TECHNICAL ADVISORY COMMITTEE REPORT

FILE NUMBER: 03-P-142c

SUBJECT: Site Plan Review for additional parking area for a previously approved Site Plan

owner/Applicant: Islander Apartments, LLC Address/Location: 5515 Plunkett Street

L1.1

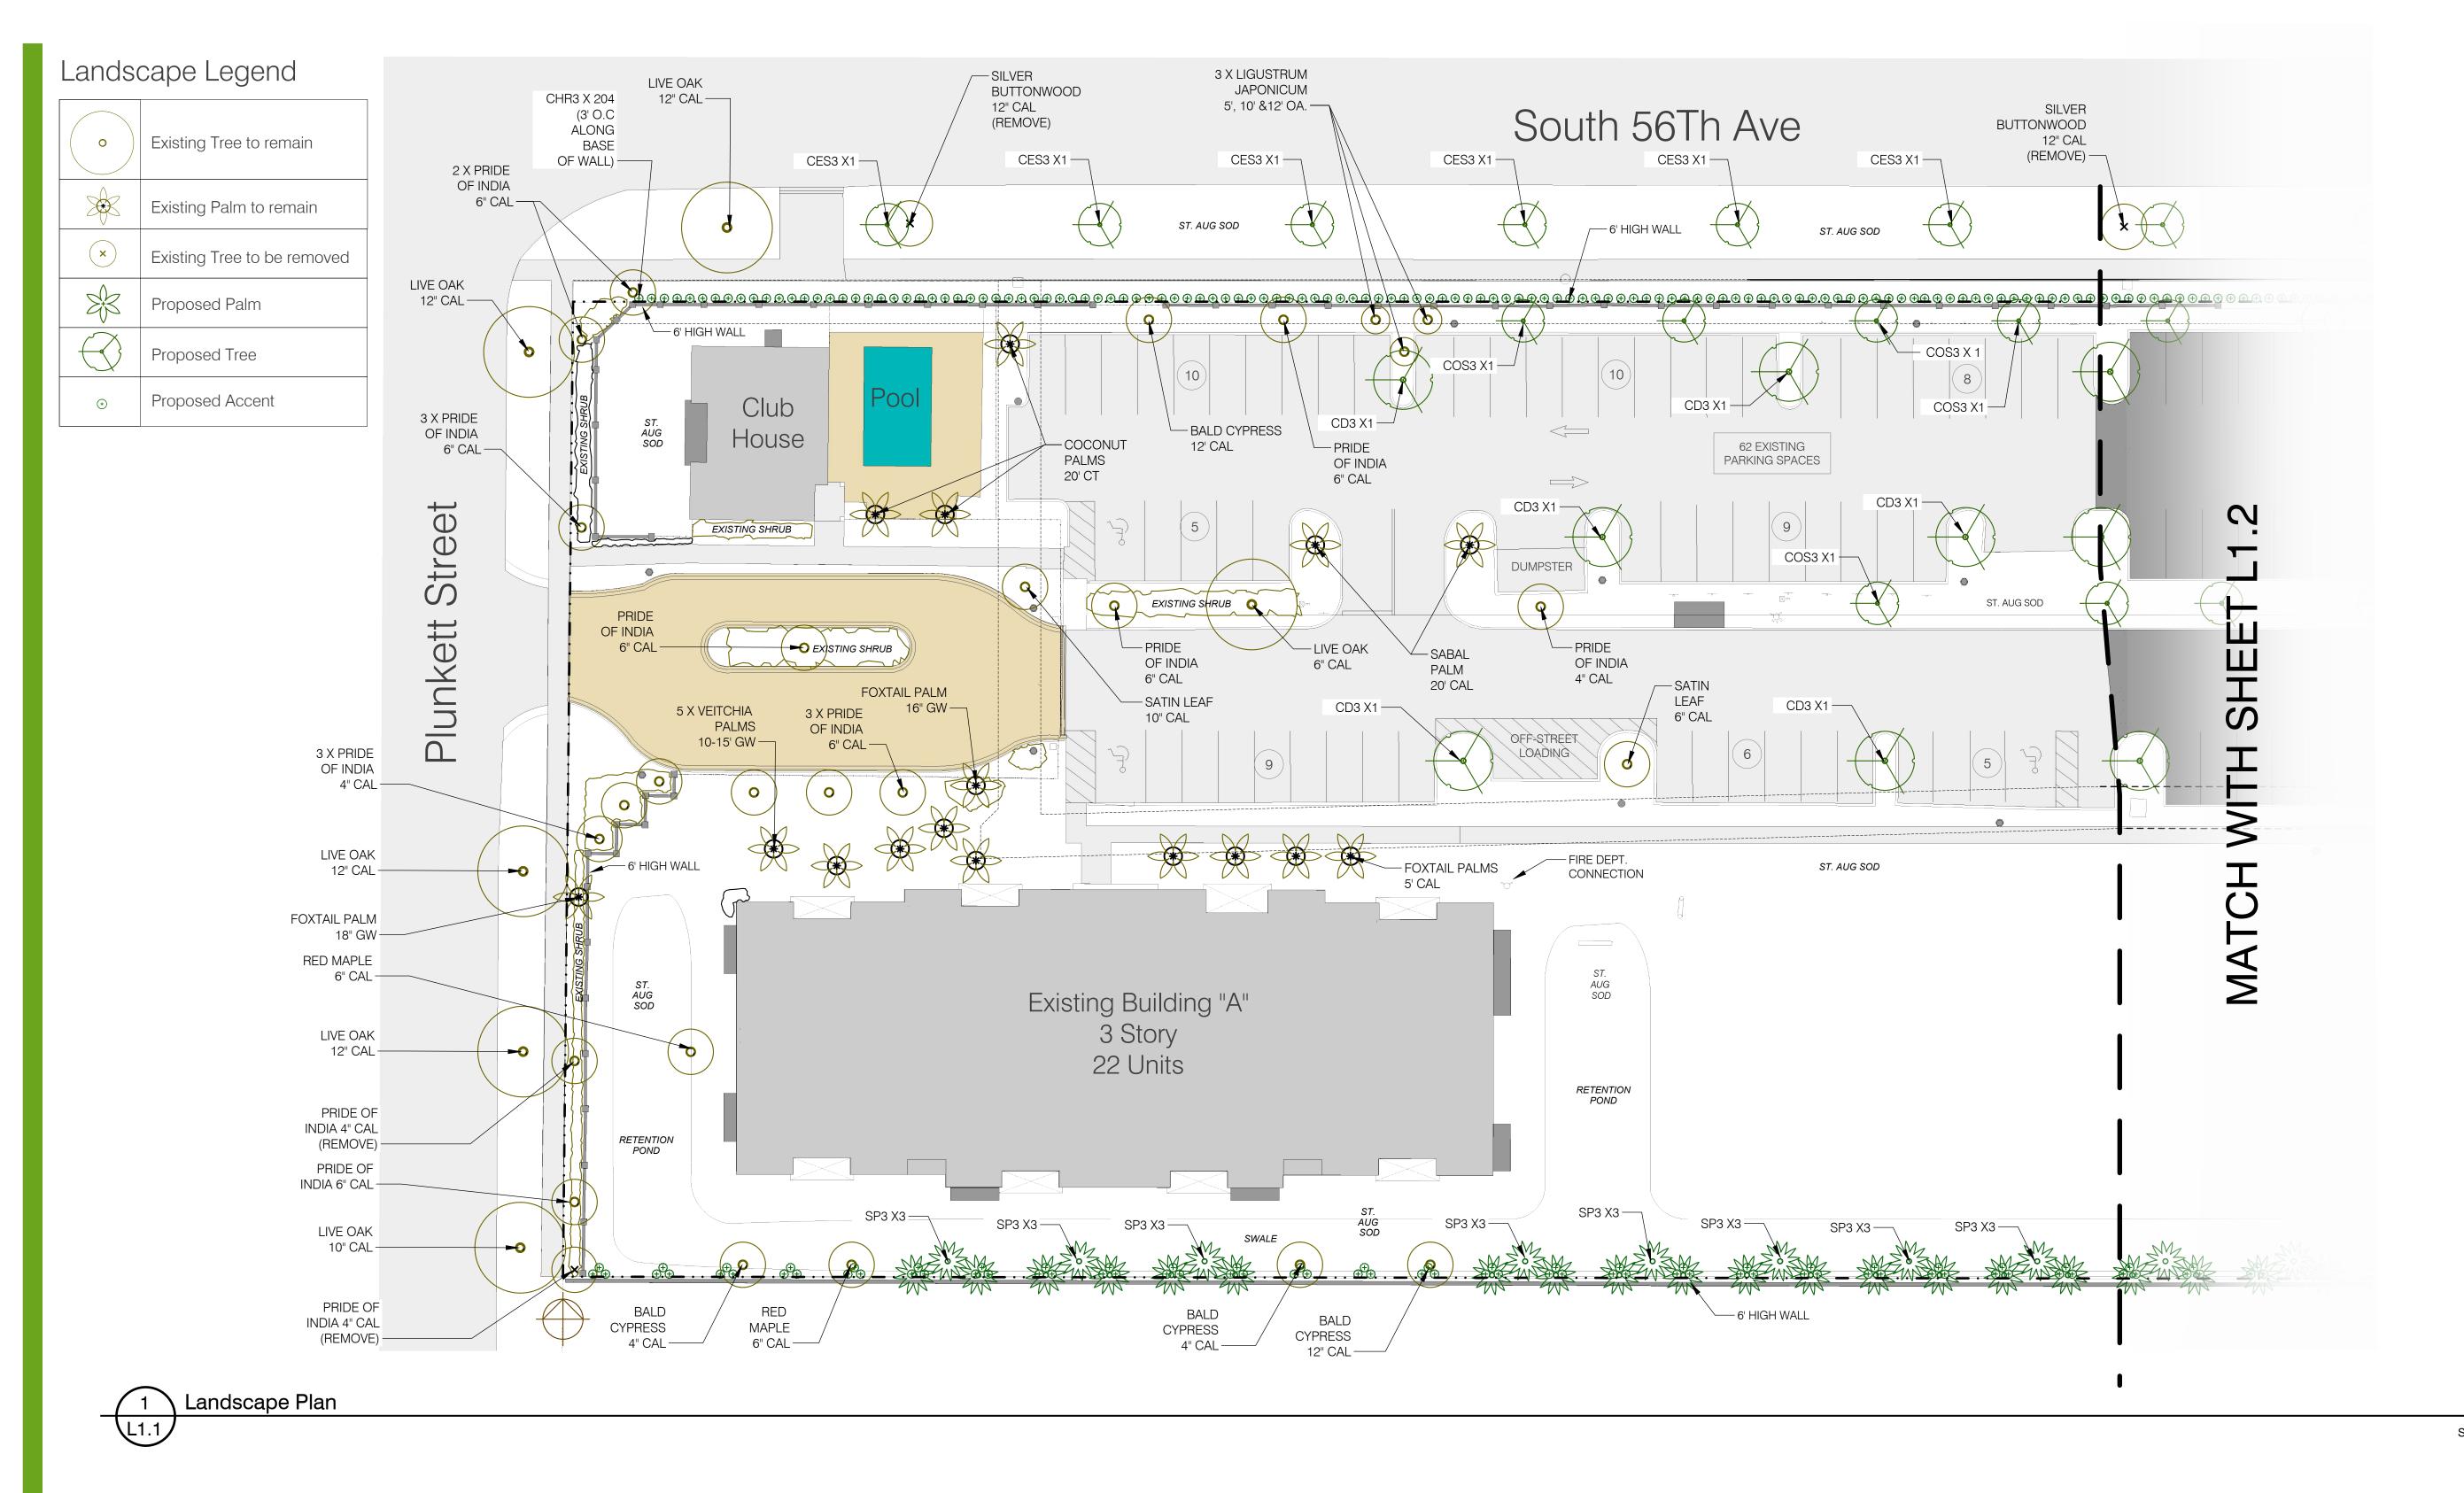
- b. Terminal islands shall have a one tree as spe; staff recommends canopy trees. Done, refer to sheet L1.1, L1.2
- c. 25% of the Vehicular Use Area shall be landscaped (values shall be validated in tabular form in the Site Data table as requested herein above).

- 1. Break up the long wall with low plant material between the back of sidewalk along South 56th Avenue and the perimeter wall. Note this area is primarily a 5 foot utility easement, so plants with small root systems would be preferable to not disturb any lines located in the easement.

1. Provide existing tree and palm information including species, estimated height and canopy/crown spread, caliper diameter of trunks, overall condition, and proposed action on a Tree Disposition Plan.

2. For any trees to be removed, provide mitigation requirements on the Landscape Plan, and how they are being met. Include a tabular data chart defining applicable requirements, and demonstrate on the Landscape Plans how they are being met.

Done, refer to sheet L1.1, L1.2

Done, refer to sheet L1.1, L1.2
- 2. For the parking lot, consider using material with high albedo to limit absorption of sunlight and reduce urban heat island effect or consider using <u>permeable paving</u> material which reduces runoff and increases water penetration.
 - Under consideration. Will provide alternates to be considered during the bidding process
- 3. Utilize street trees to discourage parking and the bading of vehicles in the swale along the east side of South 56th Avenue.

Done, refer to sheet L1.1, L1.2

No trees are currently proposed to be removed

L1.2

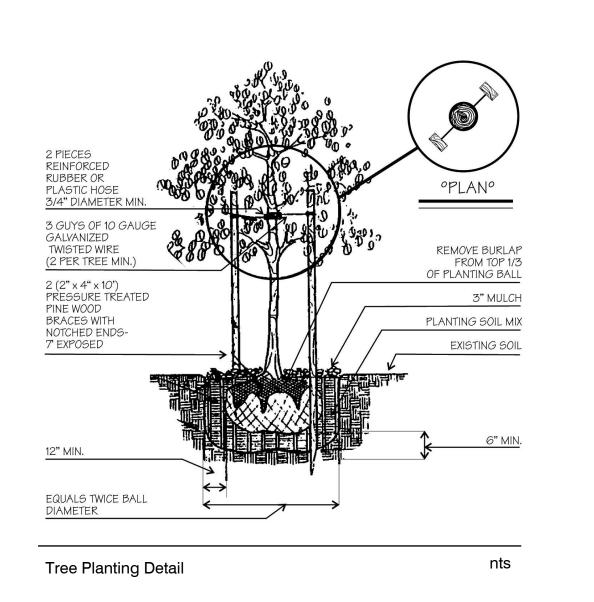
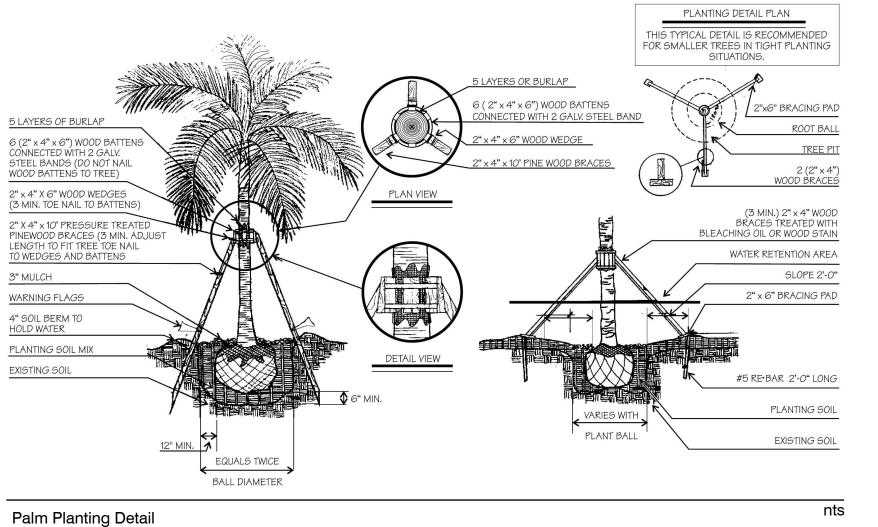
d. Water conservation methods as provided by the South Florida Water Management District shall be implemented on the landscape plan.

The irrigation shall be design as per Xerriscape principles as outlined in the land development code as note in the landscape drawings . refer to L1.2

MOZART SERIES-LED

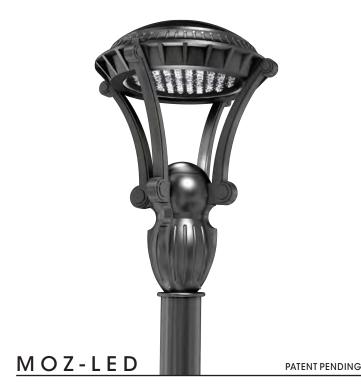
4. Provide manufacturer details on light poles and luminaire including cross sections with height, details on type of bulb and reflector.

The proposed new lighting will match the existing parking lighting and will provide degrees of illumination with a cot of o .5 f.c. at the property line
